NOV_SCE_EDC_ 20211207-01_Revised

NOTICE OF VIOLATION

Energy Safety Inspection Report

Report Name: SCE_EDC_20211207-01_Revised

Structure ID: 1289688E

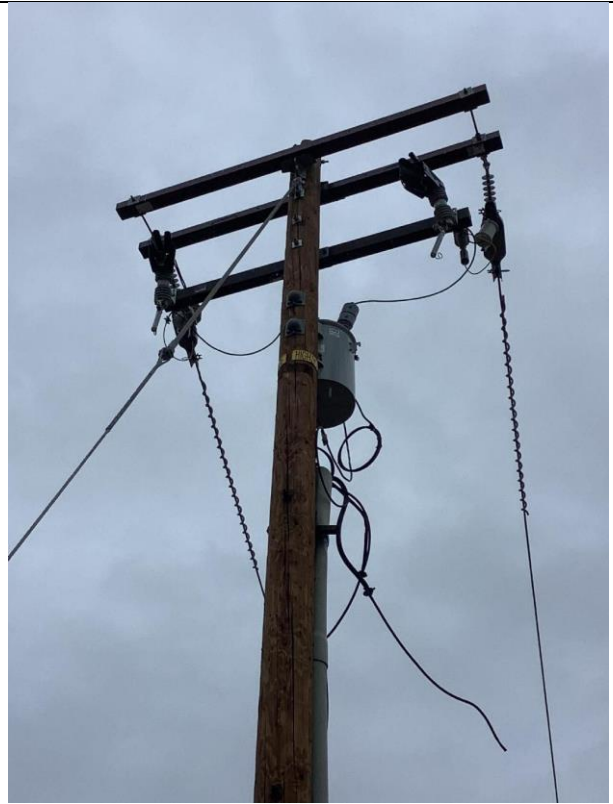
Item4IA1img1: Surge arrester clamp not covered

Structure ID: 4556900E

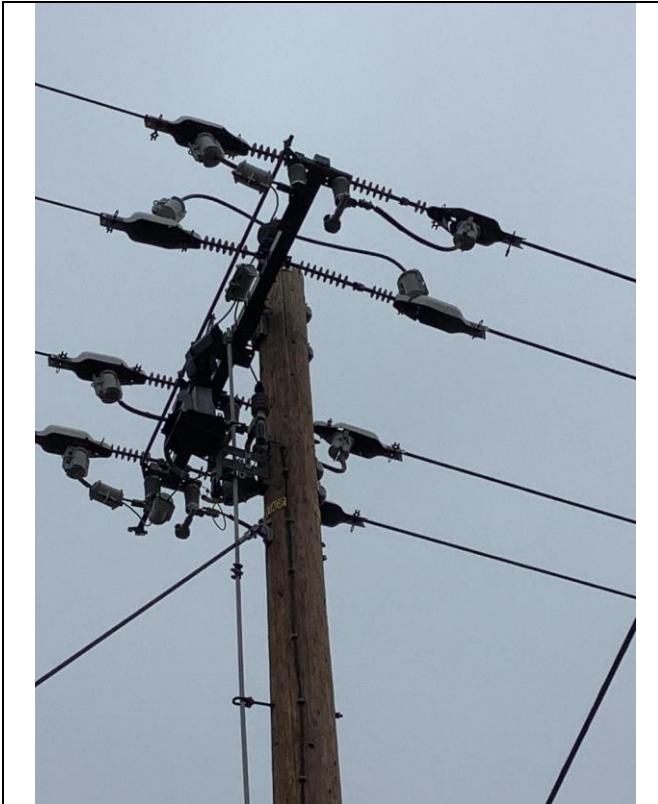
Item5IA1img1: No vibration dampers installed

Structure ID: 4554800

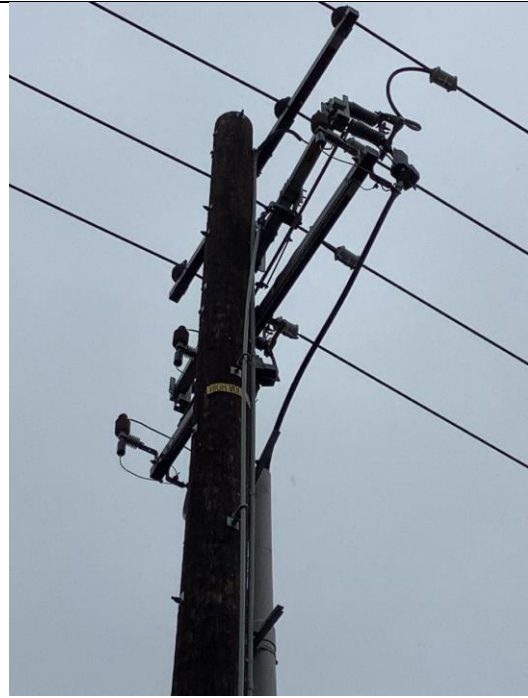
Item6IA1Img1: No vibration dampers installed

Structure ID: 4554795

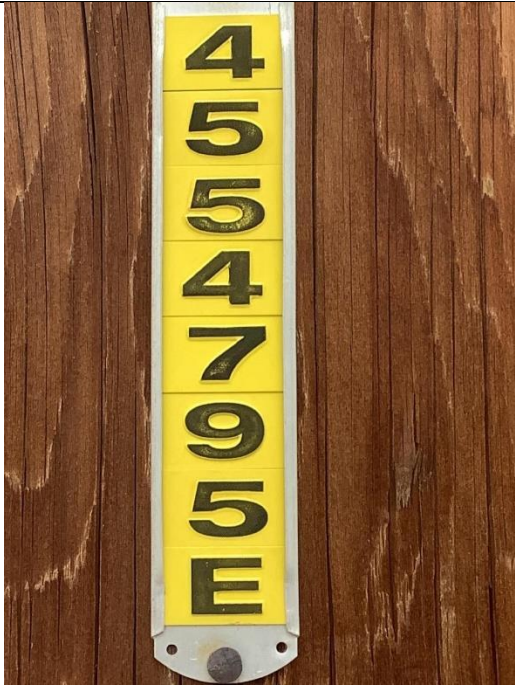
Item8IA1Img1: No vibration dampers installed

Structure ID: 4554793E

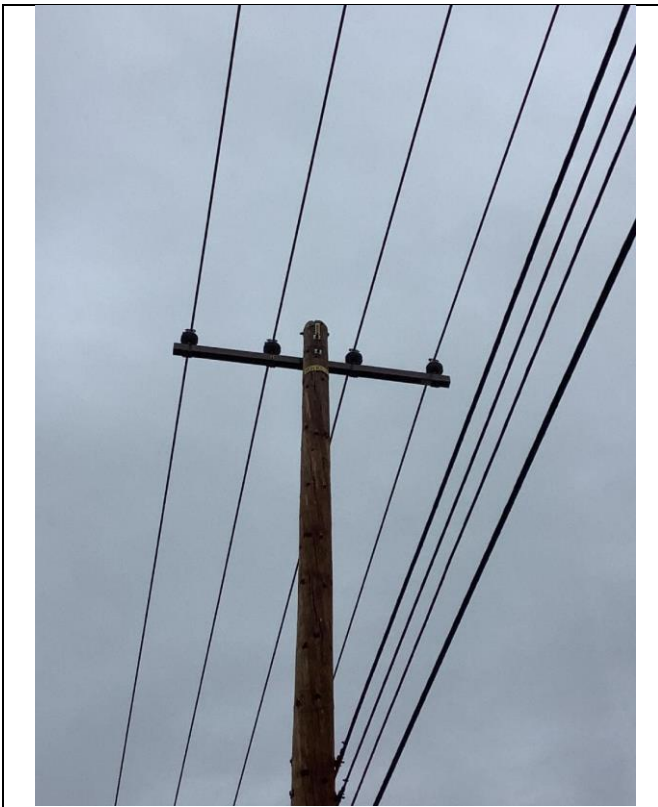
Item9IA1Img1: No vibration dampers installed

Structure ID: 4554792E

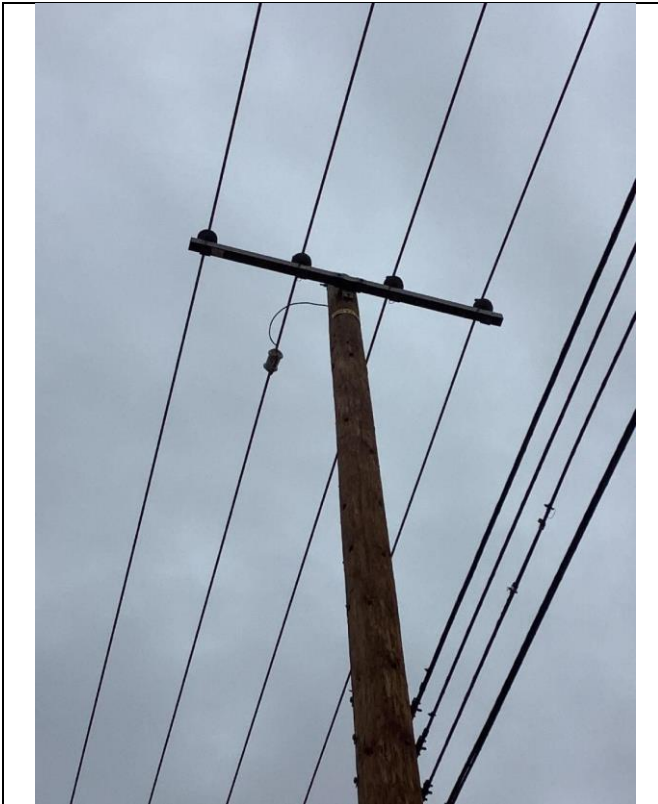
Item10IA1img1: No vibration dampers installed

Structure ID: 4554791E

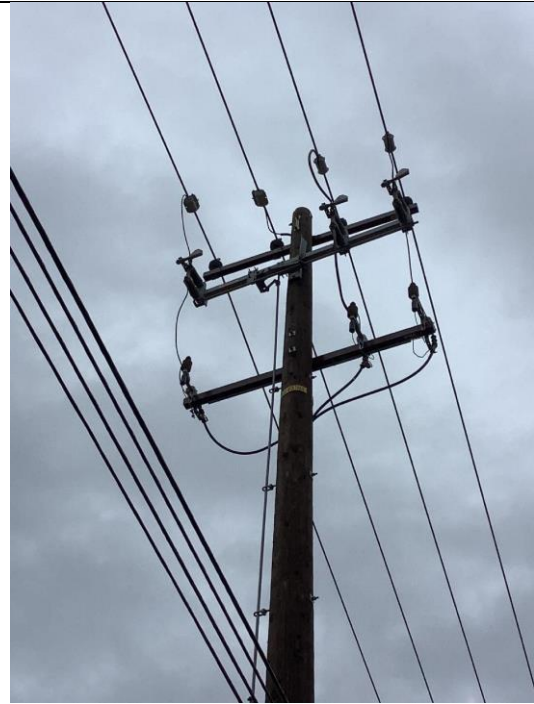
Item11IA1Img1: No vibration dampers installed

Structure ID: 4554786E

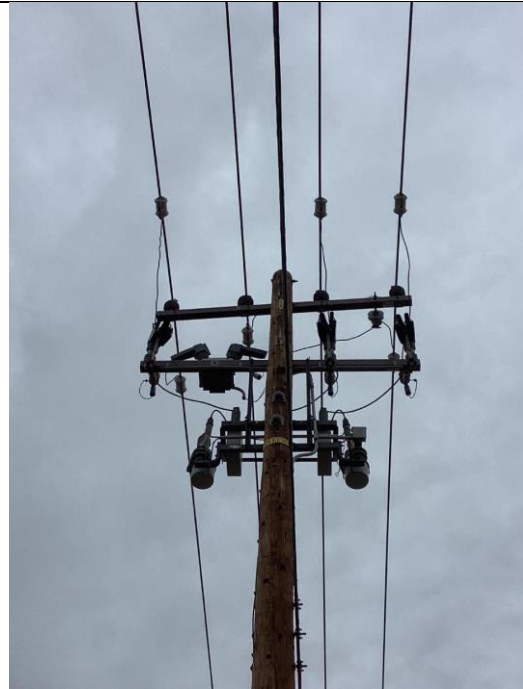
Item13IA1mg1: No vibration dampers installed

Structure ID: 276507E

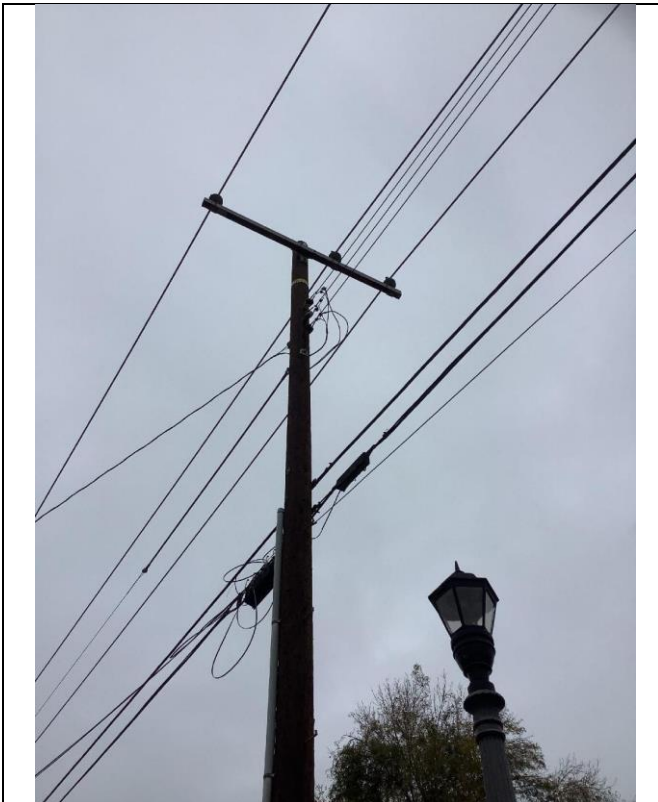
Item14IA1Img1: No vibration dampers installed

Structure ID: 4415240E

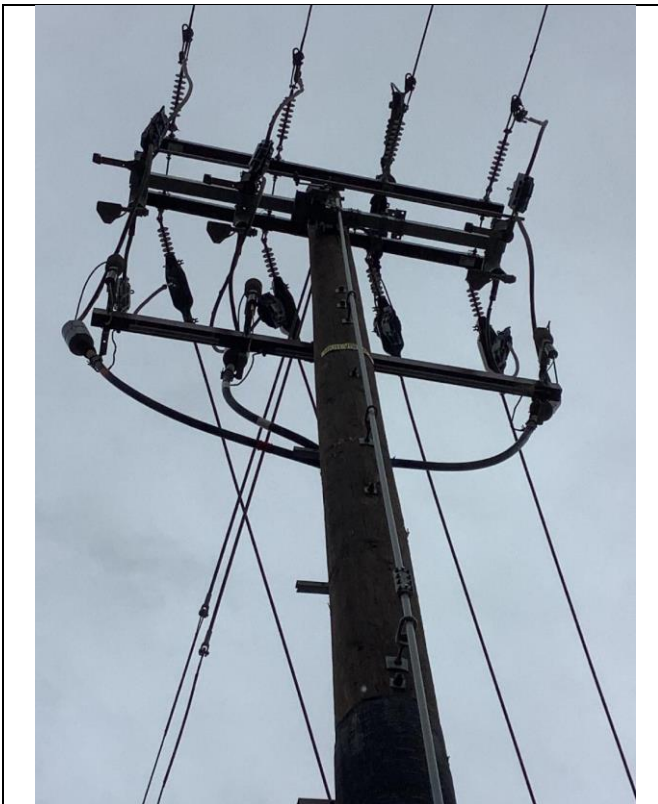
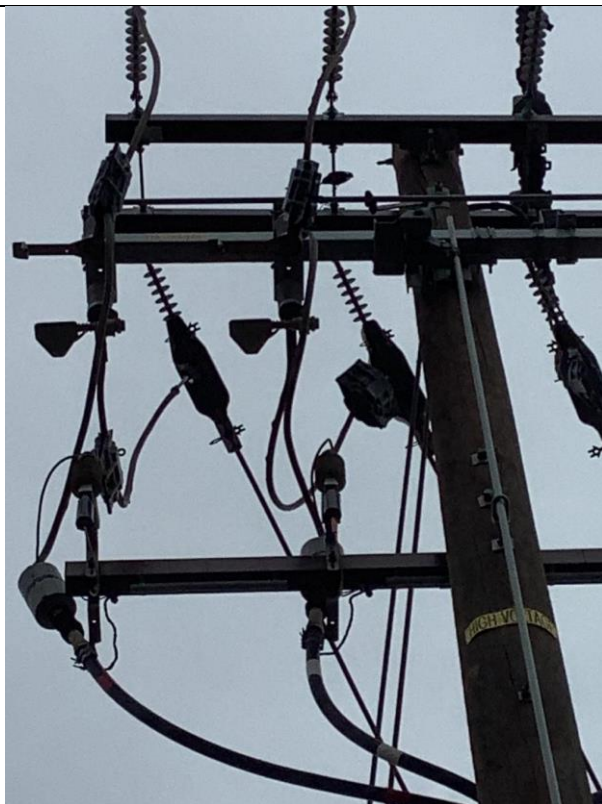
Item16IA1Img1: No vibration dampers installed

Item16IA2Img1: Bolted wedge connector cover not installed

Item16IA3Img1: No cover on jumper wire

Item16IA4Img1: Guy anchors left in in the ground

Structure ID: 4775179E

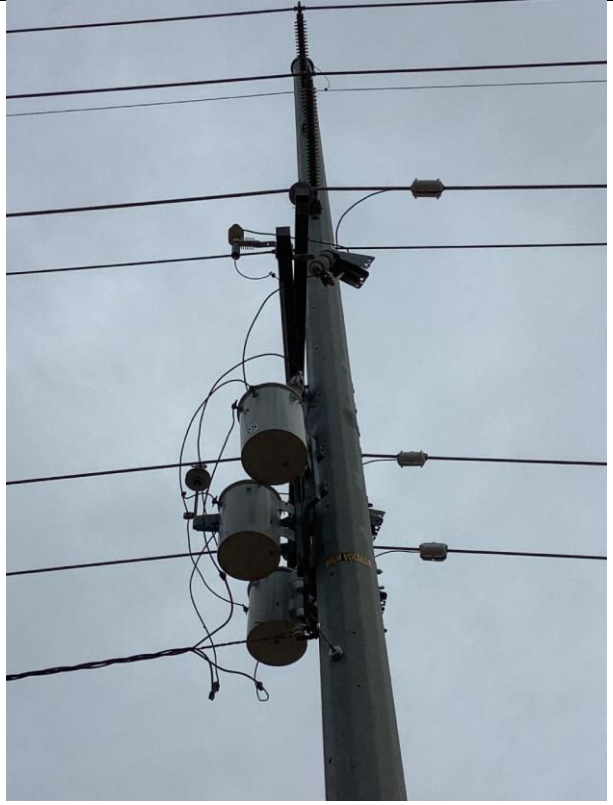
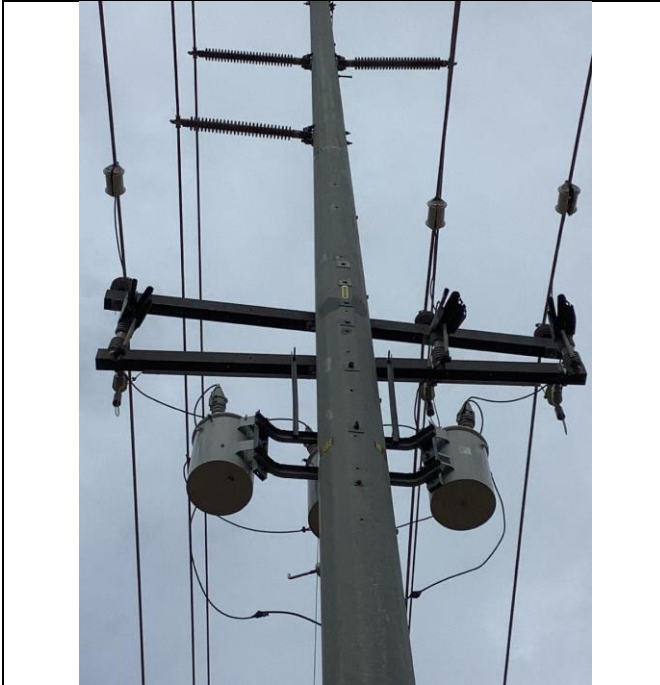
Item18IA1mg1: No vibration dampers installed
